AUTOMATIC TRANSMISSION SERVICE GROUP

**REVISED EDITION**

Since the introduction of the THM 440-T4 Transaxle in April, 1984, there have been many major engineering design changes. These changes have affected nearly every part used in the THM 440-T4. This Update Handbook will explain each change, the parts affected by the change, and any parts interchangeability problems created by the change.

Figure 23

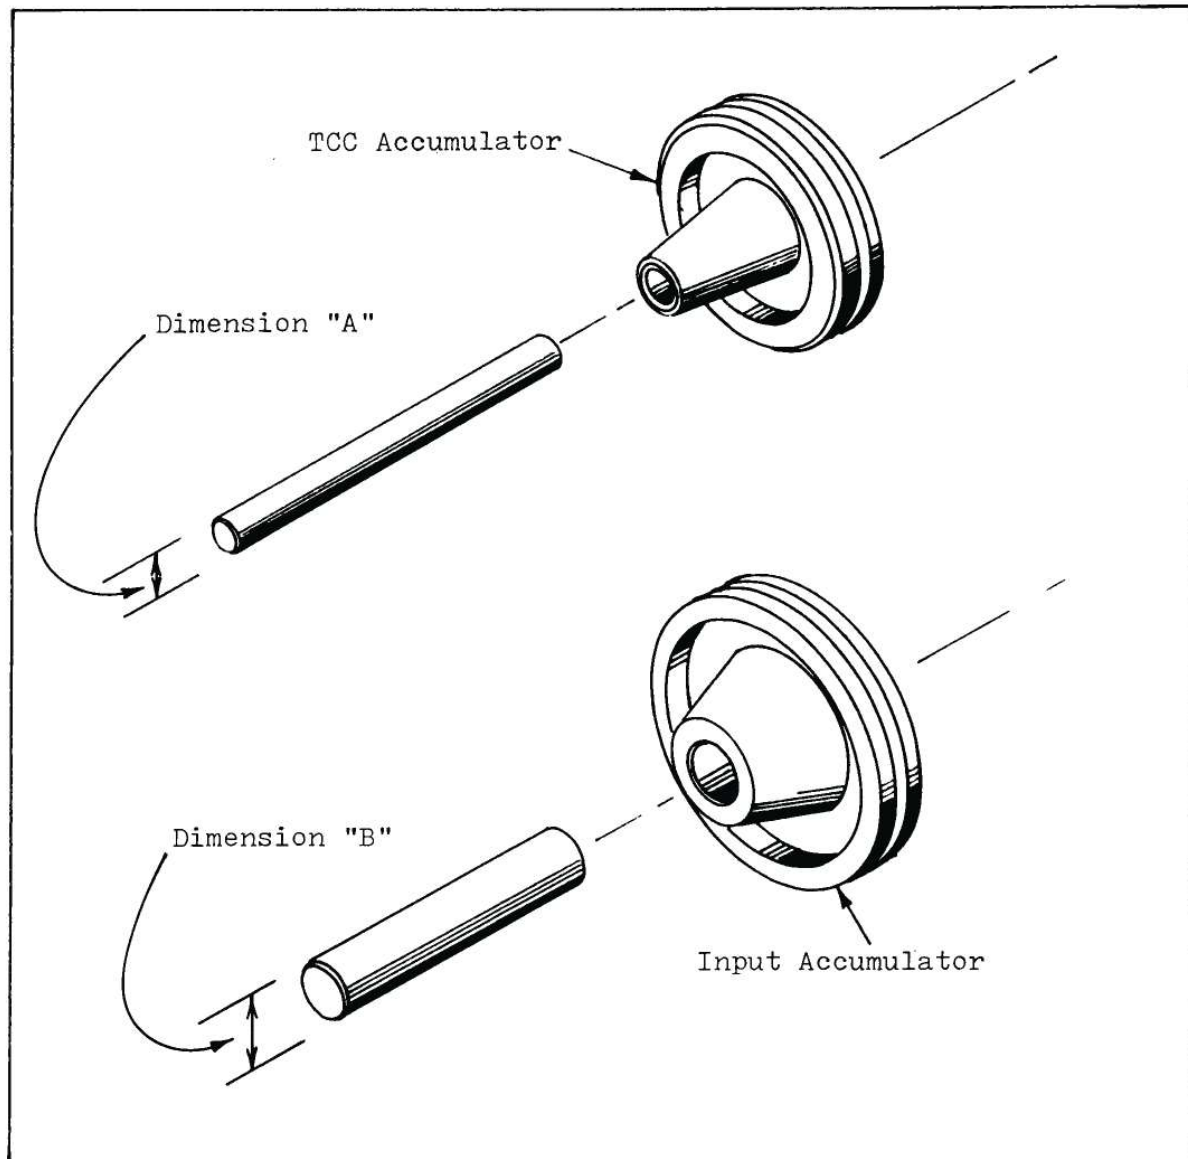
In mid 1985 the dimensions of both the TCC accumulator pin and piston, and the input accumulator pin and piston changed. We have included the dimensions of both early and late for identification purposes. (See Figure 23).

Obviously you would not be able to install the late pin into the early piston, but you could go the other way very easily. Make sure you measure these pins and "Always" up-date to the larger 2nd design.

Figure 24

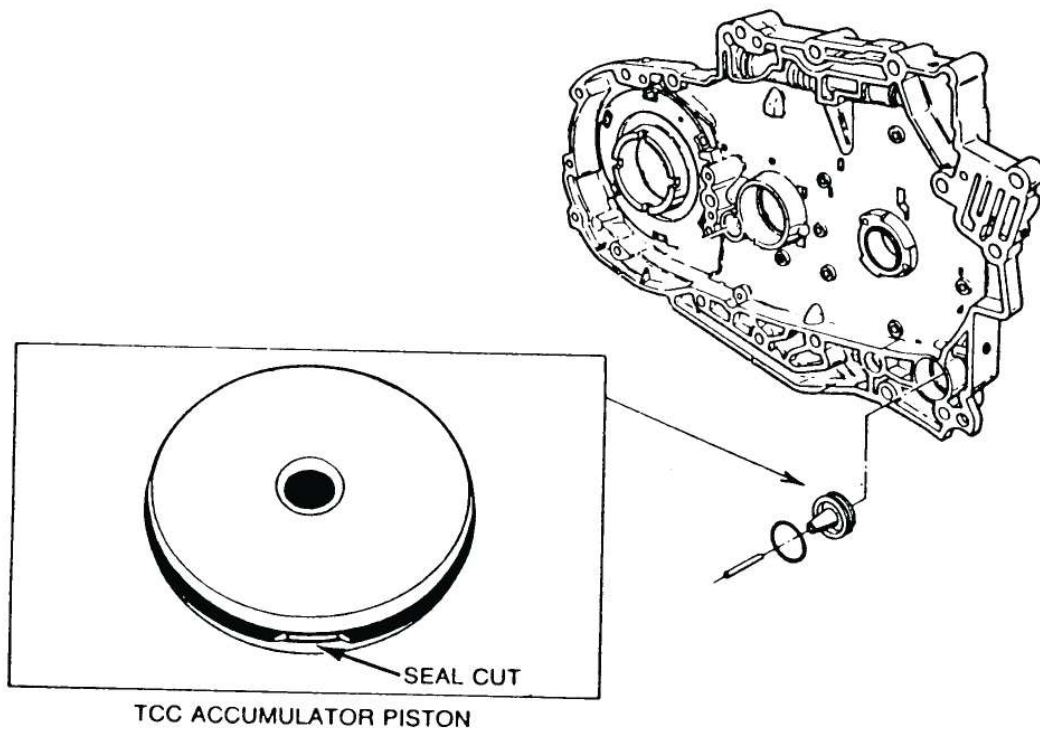
CAUSE: Some 1984 and some early 1985 THM 440-T4 transaxles may experience a no Torque Converter Clutch (TCC) apply or TCC shudder condition, which may be due to a cut or rolled TCC accumulator piston seal (See Figure 24).

CORRECTION: Install updated service package 8646926.
Updated service package 8646926 contains the following:

Figure 26

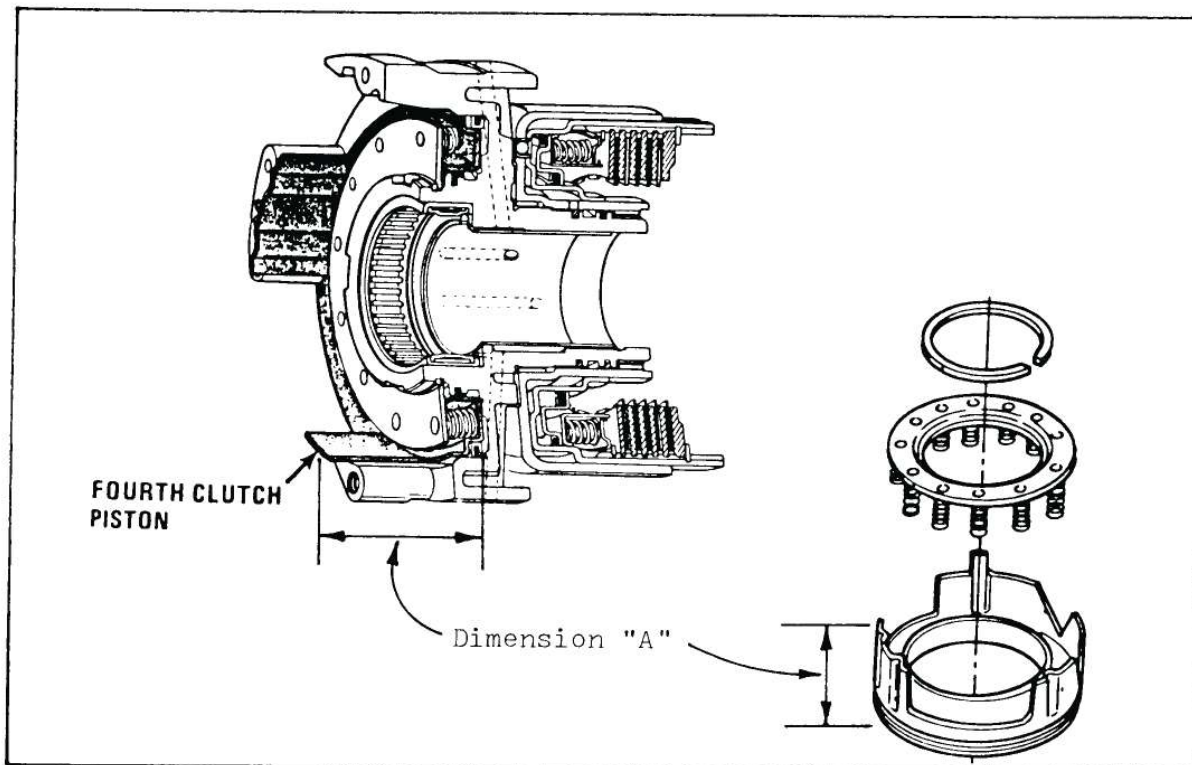
To identify, use a dial caliper set, and locked, at 1.930" and check as shown at dimension "A" in Figure 26. If dial caliper will go over the top of the piston, you have the late style piston.

If the dial caliper will not go over the top of the piston, the 4th clutch piston will have to be replaced with OEM part No. 8658388.

Figure 32

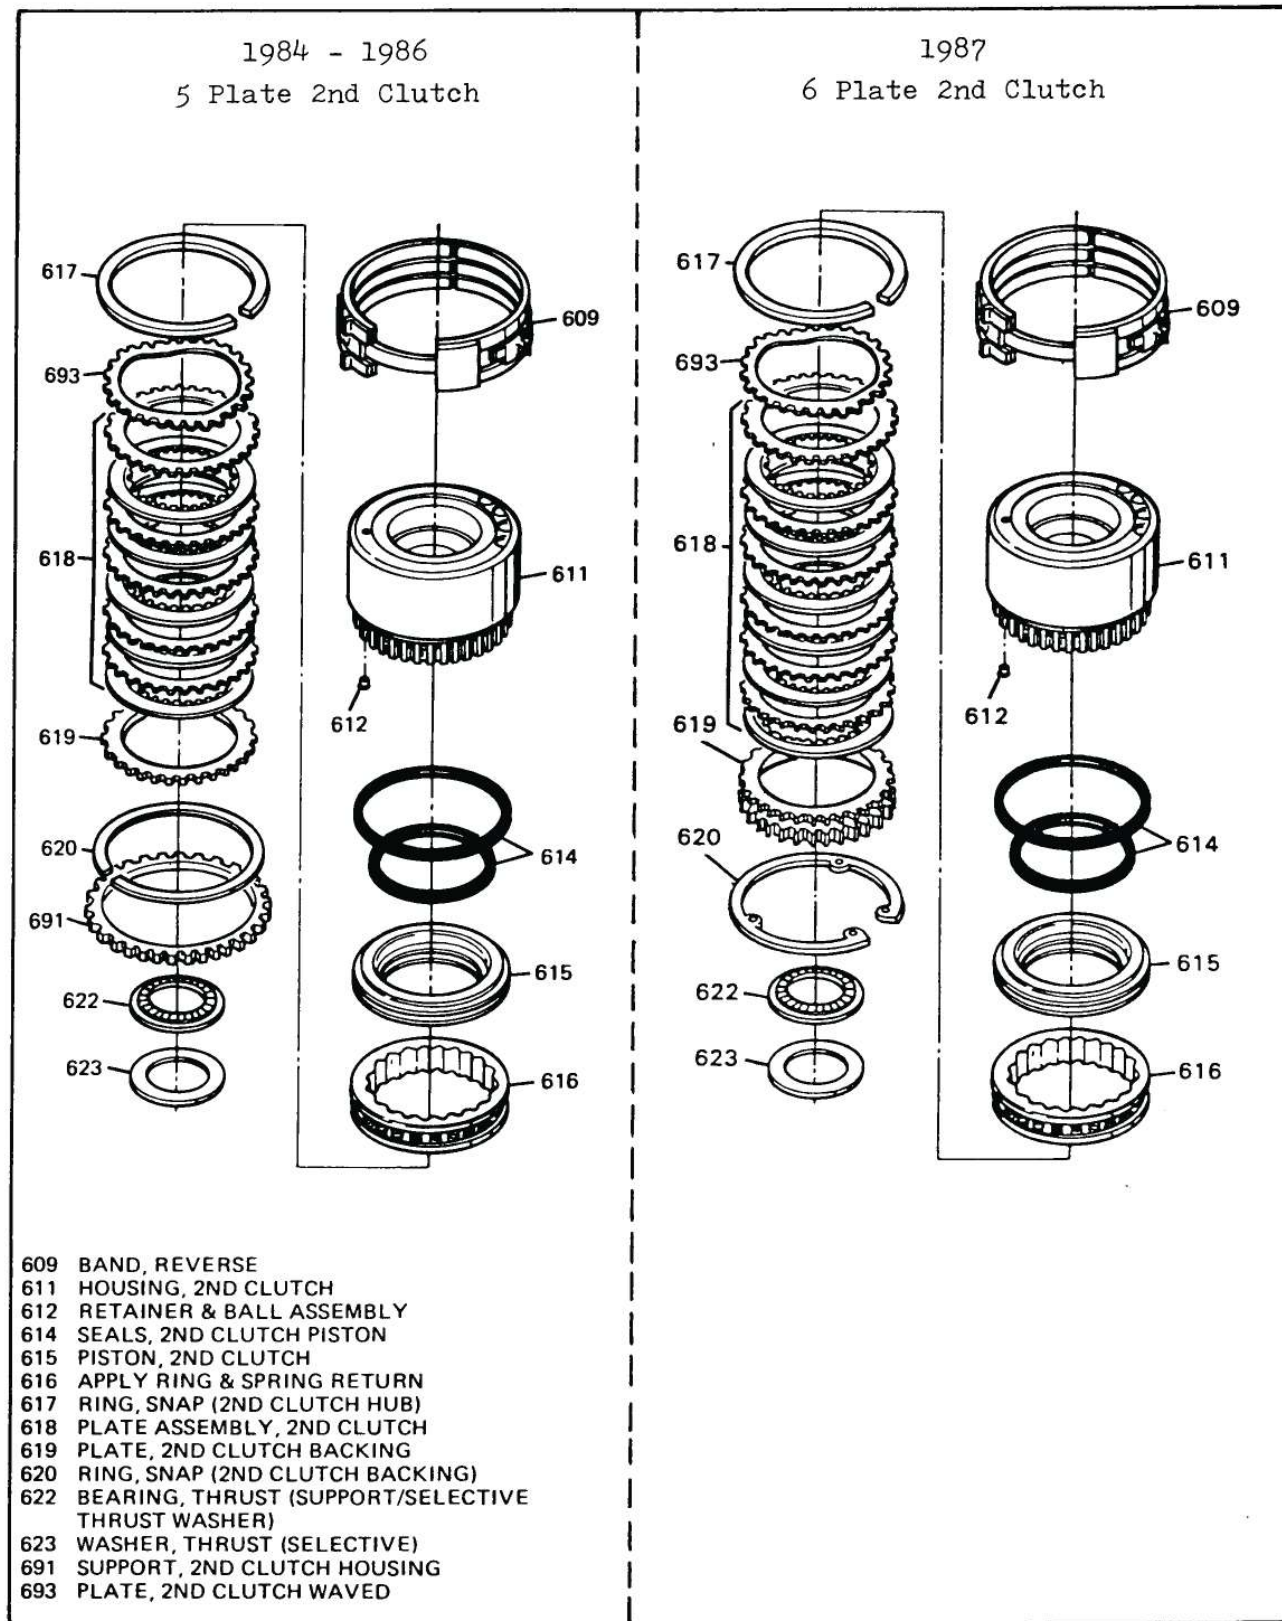
The second change on the second clutch housing occurred at the start of production for the 1987 models (August, 1986). They increased the capacity of the 2nd clutch by going to a 6 plate clutch pack instead of 5 (Compare in Figure 32).

Figure 34

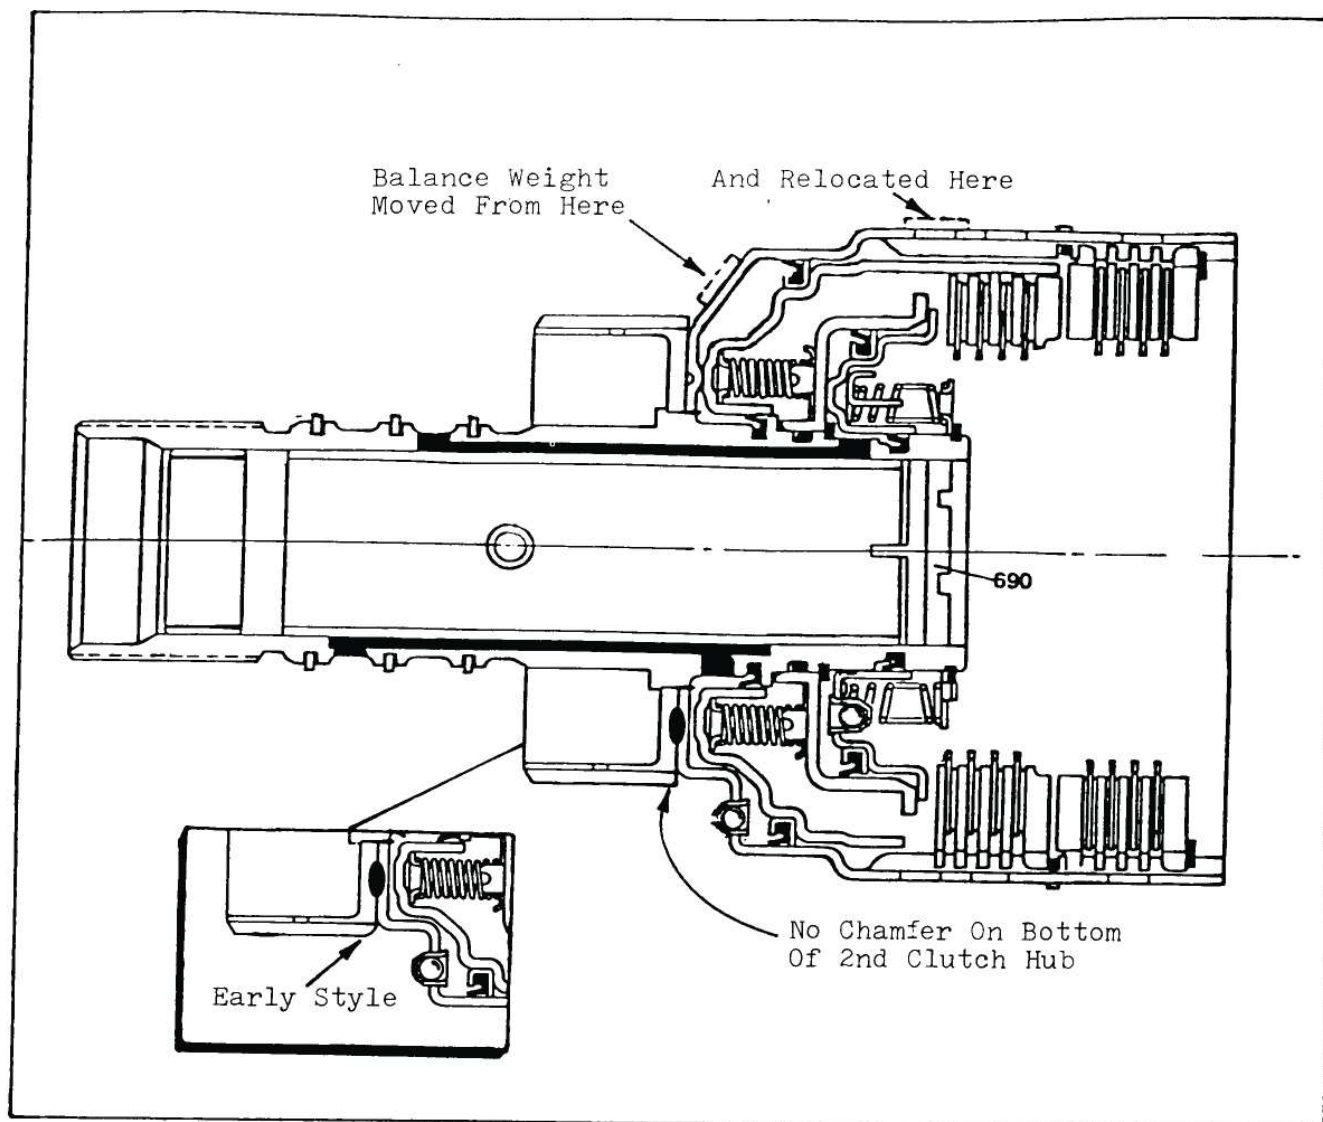
- 1) 2nd Clutch Housing - Bottom snap ring groove moved .060" toward the piston (See Figure 31).
- 2) Apply Ring And Return Spring Assy - Shortened by .060" (See Figure 31).
- 3) "Koline" Steel Clutch Plates - Revised thickness, (See Figure 35).
84-86 - 5 Plate "Kolines"--.090"
1987 - 6 Plate "Kolines"--.077"
- 4) Backing Plate - Redesigned to incorporate backing plate(619), support ring(691), and snap ring(620) into one assembly. (See Figure 32).
- 5) Reverse Reaction Plate(692) - Eliminated. If the redesigned backing plate assembly is used, you can eliminate the reverse reaction plate(692) Figure 33.
- 6) Input Housing - Revised balance weight location so as to eliminate interference with revised backing plate assembly (See Figure 34). Also no chamfer on bottom of 2nd clutch hub (See Figure 34).

The 6 plate 2nd clutch will retro all the way back as long as you have an input housing with no balance weight, or an input housing with the balance weight down on the side (See Figure 34).

Figure 35

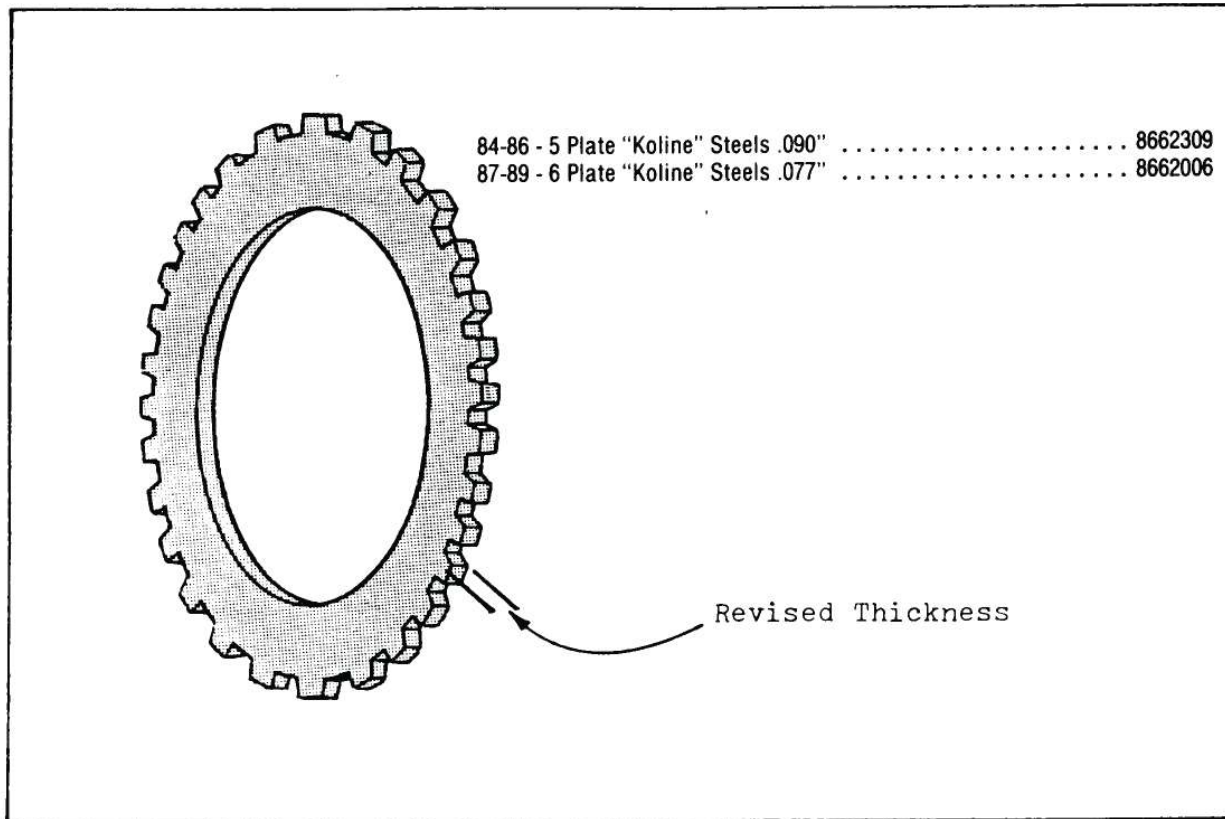
The steel plates in the 440-T4 2nd clutch are unique, in that they are black in color. They have a black coating on them called "Koline" plating, for shift pleasability (See Figure 35).

The thickness of the "Koline" plates were revised for 1987, with the addition of the 6 plate 2nd clutch pack (See Figure 35).

Figure 36

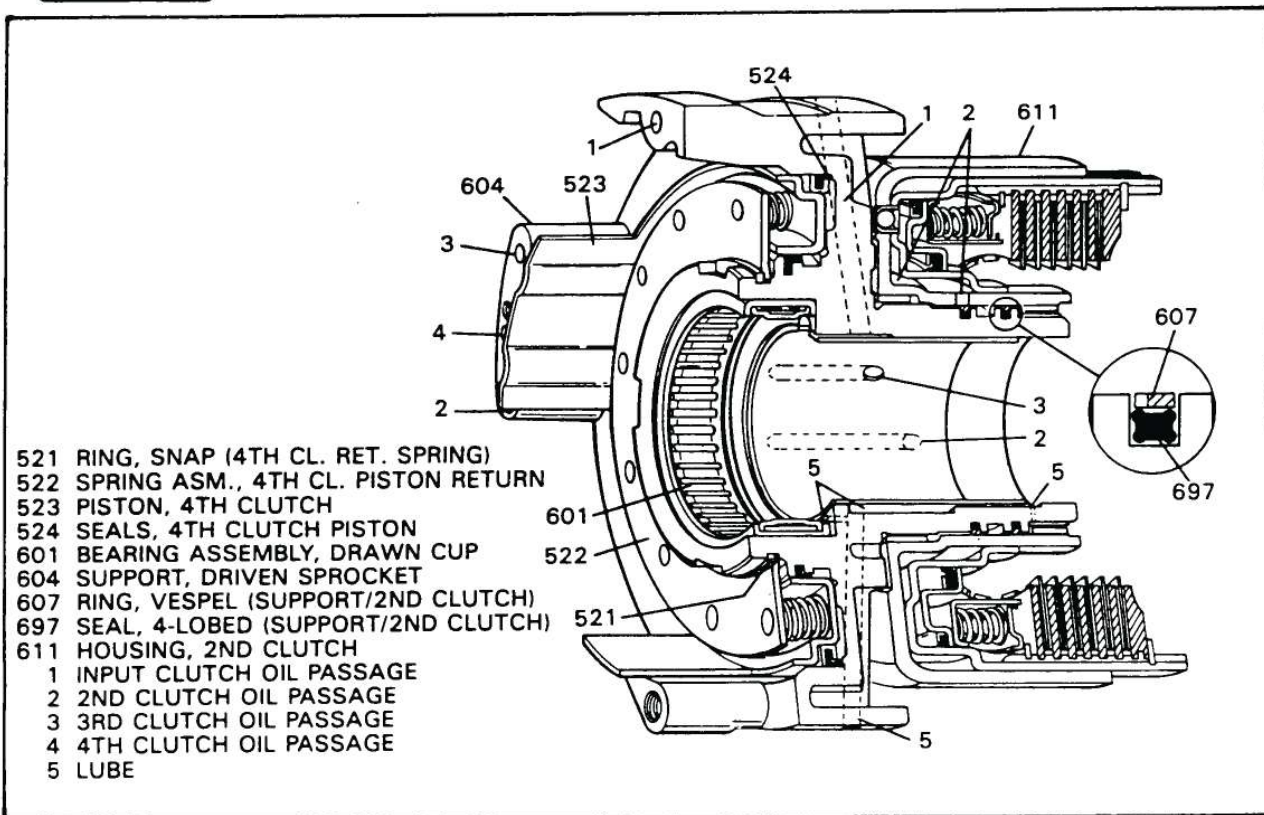
Change: "Vespel" Sealing Rings and 4 Lobe Ring (See Figure 36).

This change, also initiated in the 1987 models, related to 2nd clutch durability and was on the driven sprocket support. The 84-86 models have large steel, hook joint, sealing rings to feed the 2nd clutch. In 1987 models the steel rings were replaced with "Vespel" (Plastic), step joint, sealing rings, that have tabs on them to prevent them from spinning in the driven sprocket support (See Figure 37). This made it necessary to machine slots in the driven sprocket support, to accept the tabs on the "Vespel" rings. There is also a special 4 lobe ring that goes in the ring groove under the "Vespel" ring, and acts as an expander for the "Vespel" sealing rings (See Figure 36).

- 1) Driven Sprocket Support - Slots added to accept tabs on the "Vespel" sealing rings, and ring grooves machined deeper to make room for the 4 lobe ring (Expander).
- 2) No. (697) 4 lobe ring acts as expander for (607) "Vespel" sealing ring (See Inset, Figure 36).

Figure 40

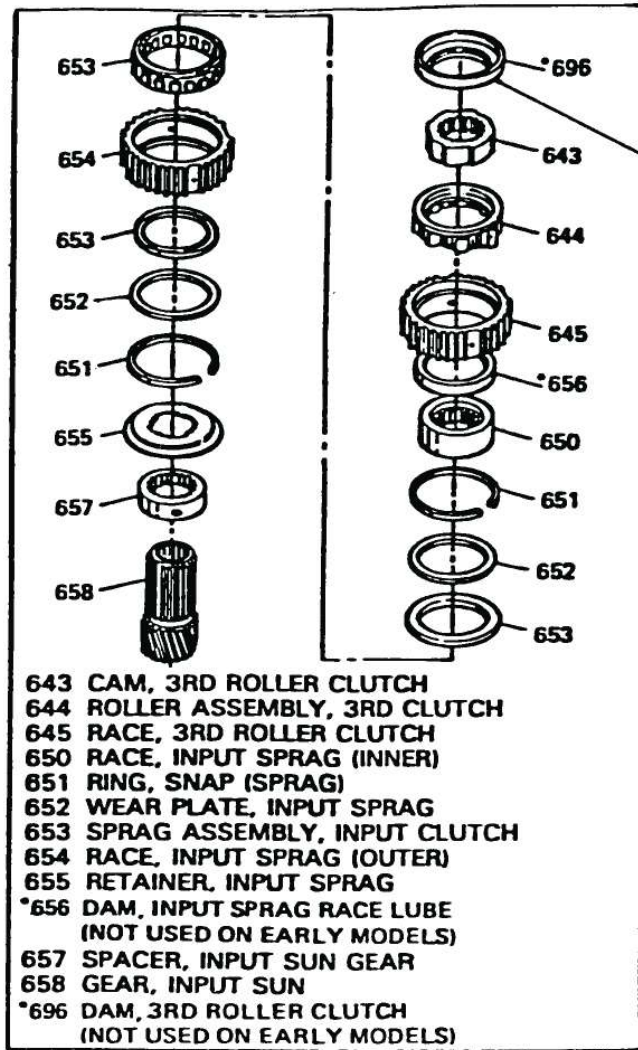
Change: Addition of "Oil Dam" to 3rd roller clutch (See Figure 40).
